CORNERSTONE
AGOURA ROAD, AGOURA HILLS, CALIFORNIA

Re: *Shared Parking Study & Parking Management Plan
Cornerstone Mixed Use Development
Agoura Hills, CA*

Thank you for passing along the City's comments related to Walker's Shared Parking Study and Parking Management Plan for the proposed Cornerstone Mixed-Use Project. We have provided the response to specific comments within the body of this letter (below). All comments noted as addressed within the body of the report, are incorporated within the attached document.

Figure 1: Market Area

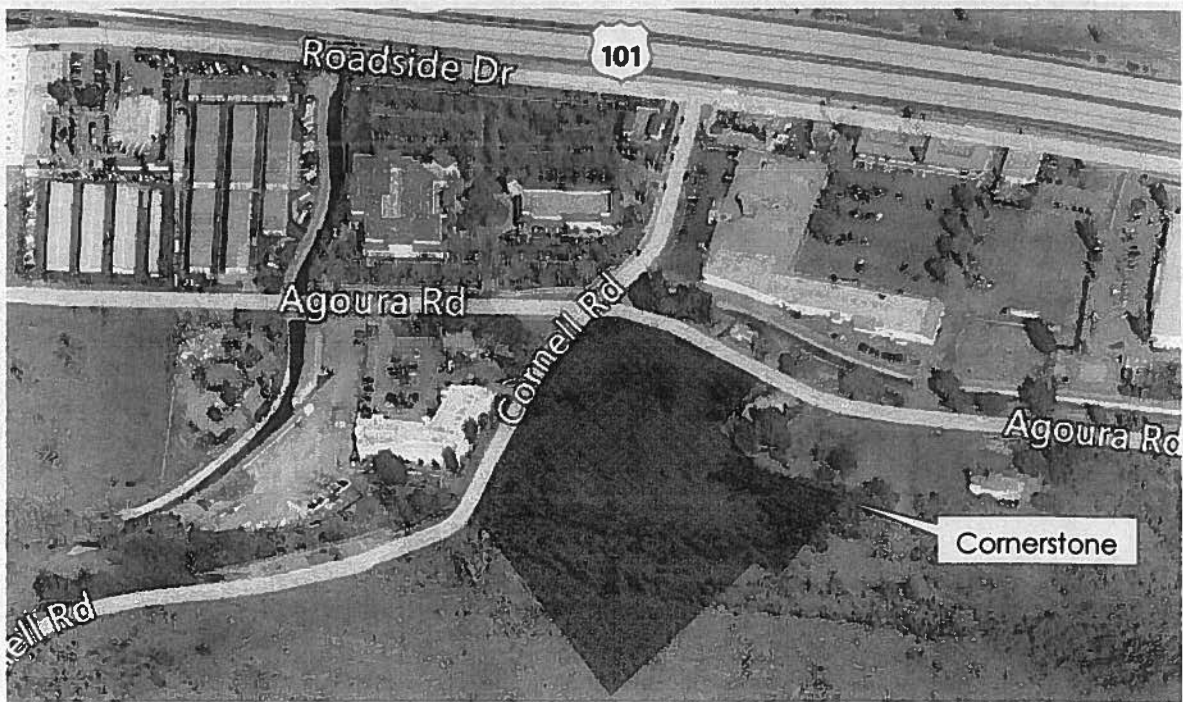
Comment #1 (page 3)

Figure 1 -has been adjusted
